DRAFT / APPROVED MINUTES OF THE MEETING

October 2, 2008

| October 2, 2008 | Project: | Epiphany School |
| | Phase: | Alley Vacation |

Landscape Design

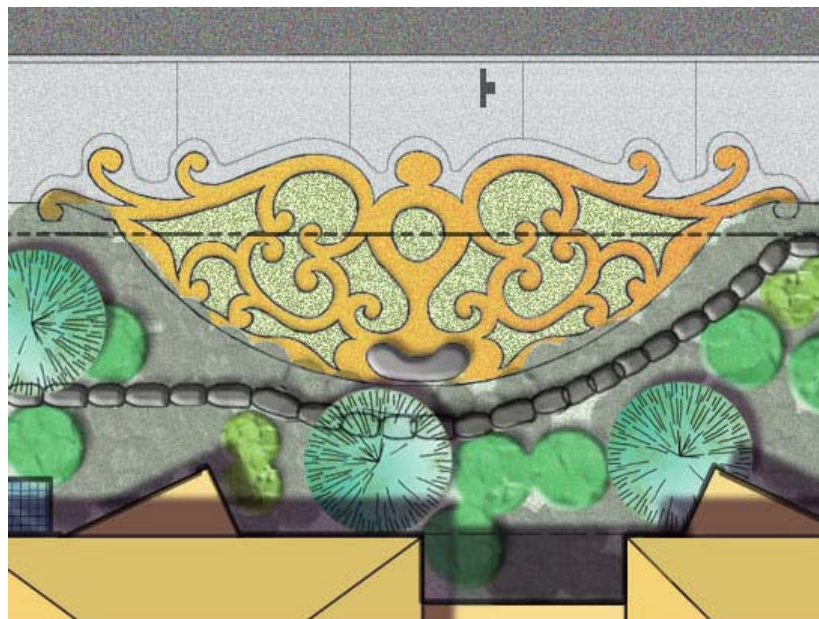
If it's intended to be a public play area after hours, it's not very transparent due to concrete walls and hedges. It needs a visual connection between sidewalk and neighborhood. One gate at the south end is not a very strong connection to neighborhood. A north end gate on Denny would be a better utility to the neighborhood.

The public benefit is on the northwest corner of the site; this is a good corner. The proposal is much stronger in response to children using the smaller play area, but its public access is not clear. The garden could reference the corner. The drawings don't show dimensions of the pedestrian zone, which minimizes the impact of the art piece. There is lack of clarity on how it relates.

On the site plan, the garage driveway is prominent, and it may read as the entrance; suggest minimizing the length of the curb cut.
